JUMBO MINING COMPANY
6305 Fern Spring Cove
Austin, Texas 78730

RE: Additional information re-
quested in ~~operation letter 12/24/91~~
for new ~~heap~~ leach pad H-10,
Drum Mine

The following information is being submitted as requested in the BLM's letter dated 12/24/91.

FIG.1

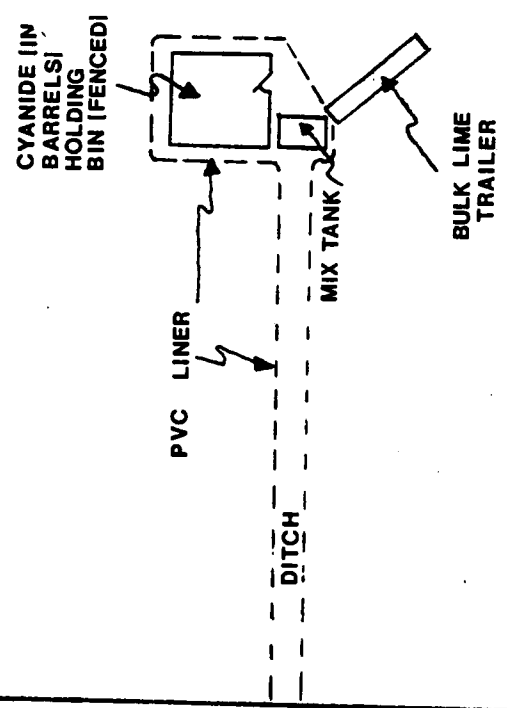
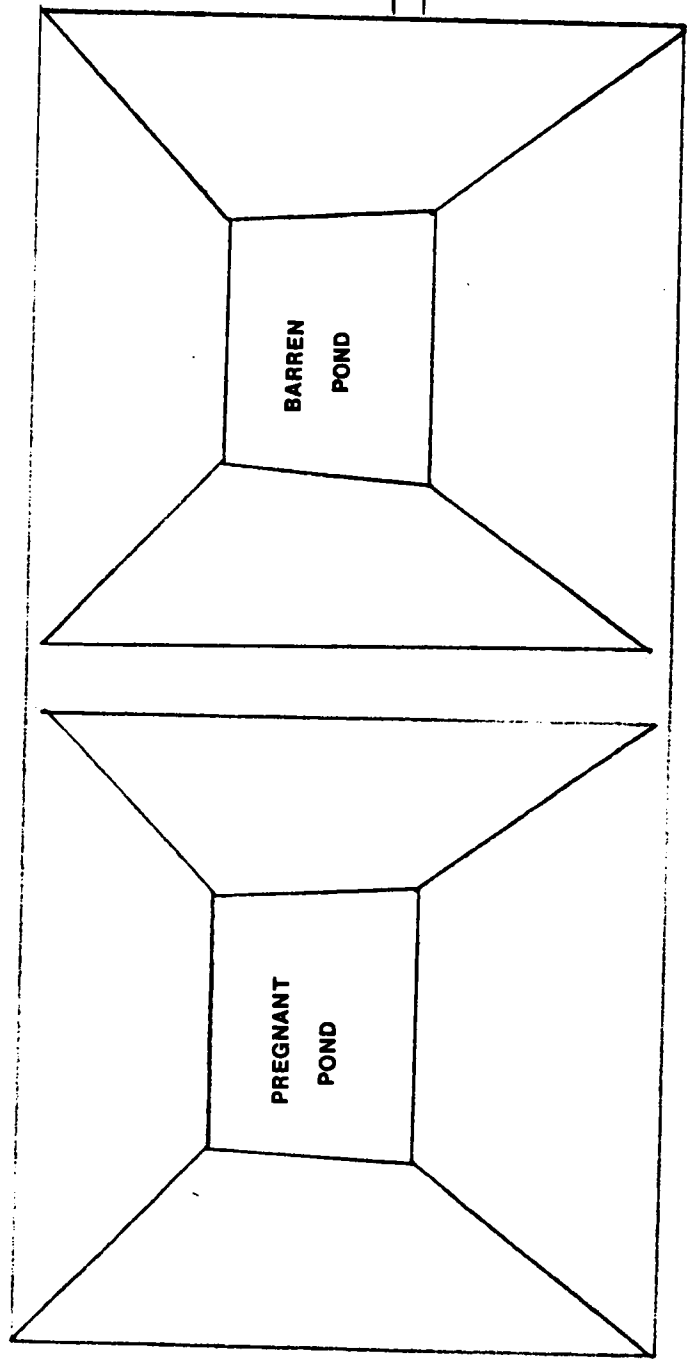
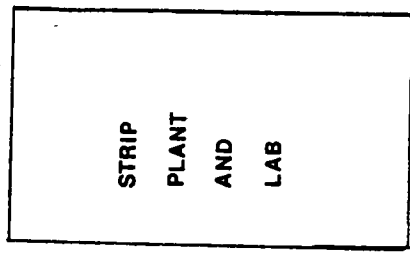
B. Containment procedures and facilities. All cyanide will be stored in sealed barrels on top of a PVC liner and inside a chain link fence (see fig. 1). The PVC liner will be placed next to the mixing tank and will be constructed so that any spill will flow into the barren pond and be contained within our closed system solution circuit.

C. Available list and location. Equipment at the site consists of two rotary drills, three 35-ton haul trucks, three front-end loaders, two dozers, one water truck and various support vehicles, pumps, etc. The equipment is located just north and east of the strip plant and lab shown on figure 1.

1. Lime from the bulk trailer (see fig. 1) will be placed upon the spill to prevent any gas from being created.
2. The front-end loaders and haul trucks will load and haul the pellets and at least one foot of underlying soil. The soil and cyanide will be placed on top of our heap where the cyanide will dissolve and thus be contained within the closed circuit.
3. Samples from the underlying soil will be analyzed in our lab immediately in order to determine if more soil removal is needed.
4. A berm will be constructed around the spill area to prevent any rain runoff from entering.
